The Guildford Society
24 Bury Fields
Guildford
Surrey GU2 4AZ

23rd February 2020

Response to the consultation on Strategic Sites SDF/SPD

Profile B - Dedicated busway

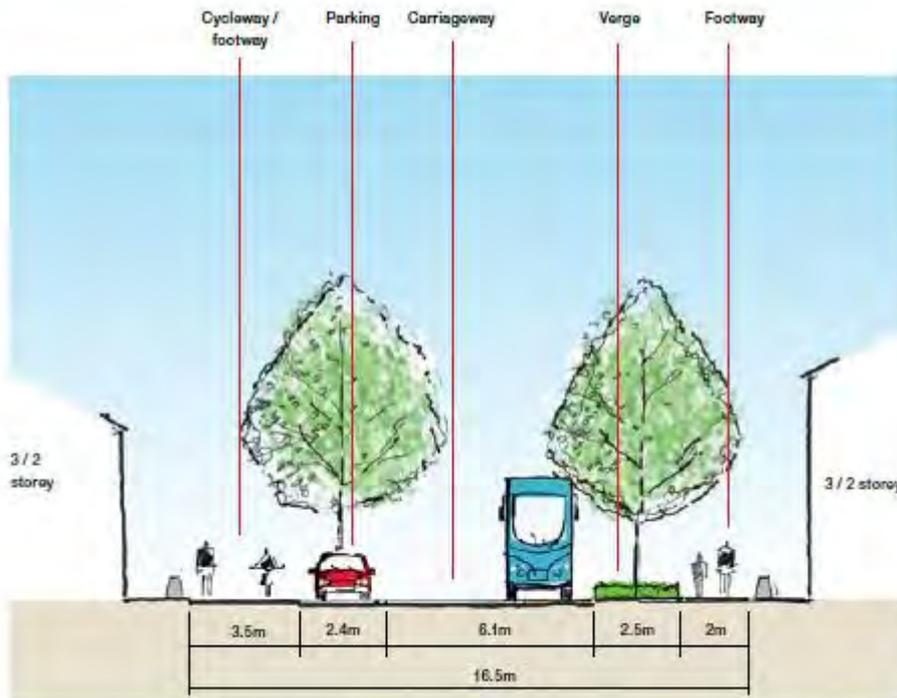
We are concerned that the hierarchy is a city/town based solution as proposed. How a SMC fits into a lower density development that will occur on some sites needs definition.

The SMC as proposed for a primary street is going to be circa 16-25m wide accommodating this within some of the developments is going to be a design challenge. We also note that other configurations can be considered including total separations of traffic modes as shown below.

Developers need to be free to consider how best to accommodate SMC’s within an overall policy of separating modes as far as is practical.
